**Requested Amendments to Draft Conditions of Development Consent DA18/1448  
Stage 1 Precinct of Woollooware Bay Town Centre**

We write in relation to Development Application DA18/1448 (PPS-2019SSH002) in relation to the development of the Stage 1 Precinct of Woollooware Bay Town Centre at 455 Captain Cook Drive, Woollooware, which is scheduled to be considered by the Panel at its meeting of 15 July 2020.

## Appendix A. Proposed Amendments to Draft Conditions

**Figure 9 Preliminary staging plan**

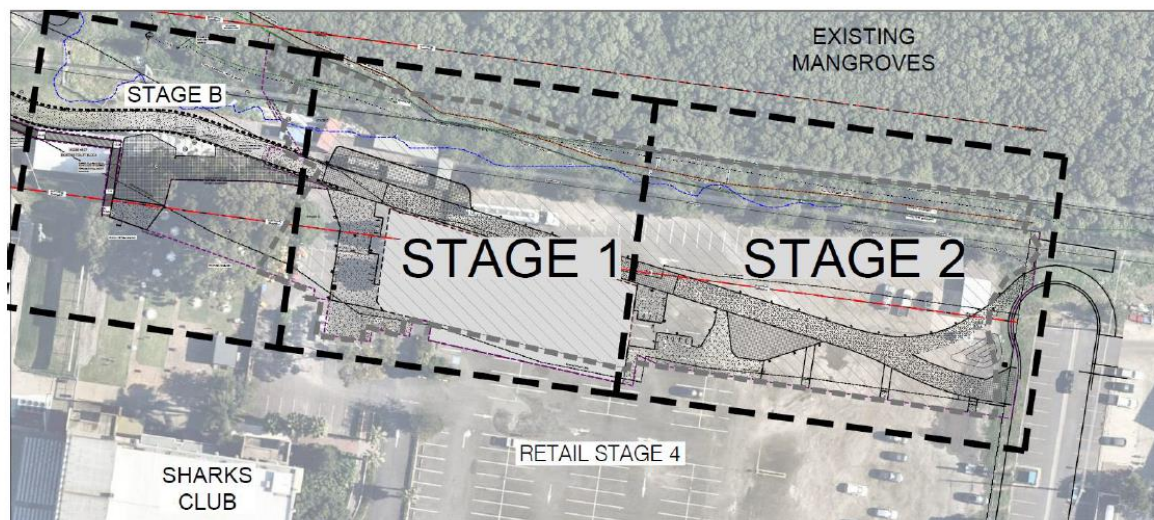
As noted in the staging plans submitted with the DA (refer extract below), part of the foreshore landscaped area is required for construction materials handling, loading and lifting to facilitate the construction of the residential buildings above. This is critical as these activities are not able to be undertaken from the Captain Cook Drive or Woollooware Road North frontages.

As outlined in DA20/0266 (refer to extract from SEE below), it is proposed that Stage 1 would be completed prior to the occupation of the Retail/Club component (Stage 2 Occupation Certificate), whilst Stage 2 would be completed prior to the issue of any Occupation Certificate for a residential dwelling. Proposed conditions to this effect are included to the left.

**An Occupation Certificate must not be issued for the retail centre until the foreshore landscape and civil infrastructure works identified as Stage 1 under DA20/0266 (as detailed in the Construction Staging Plan L-C-01(L) by Habit8 dated 30 March 2020) are fully constructed and an Occupation Certificate for the works has been granted. Evidence of the issue of this Occupation Certificate must be provided to the satisfaction of the Principal Certifying Authority prior to the issue of the Occupation Certificate for the retail development.**

**An Occupation Certificate must not be issued for any residential dwelling until the foreshore landscape and civil infrastructure works identified as Stage 2 under DA20/0266 (as detailed in the Construction Staging Plan L-C-01(L) by Habit8 dated 30 March 2020) are fully constructed and an Occupation Certificate for the works has been granted. Evidence of the issue of this Occupation Certificate must be provided to the satisfaction of the Principal Certifying Authority prior to the issue of the Occupation Certificate for the retail development.**
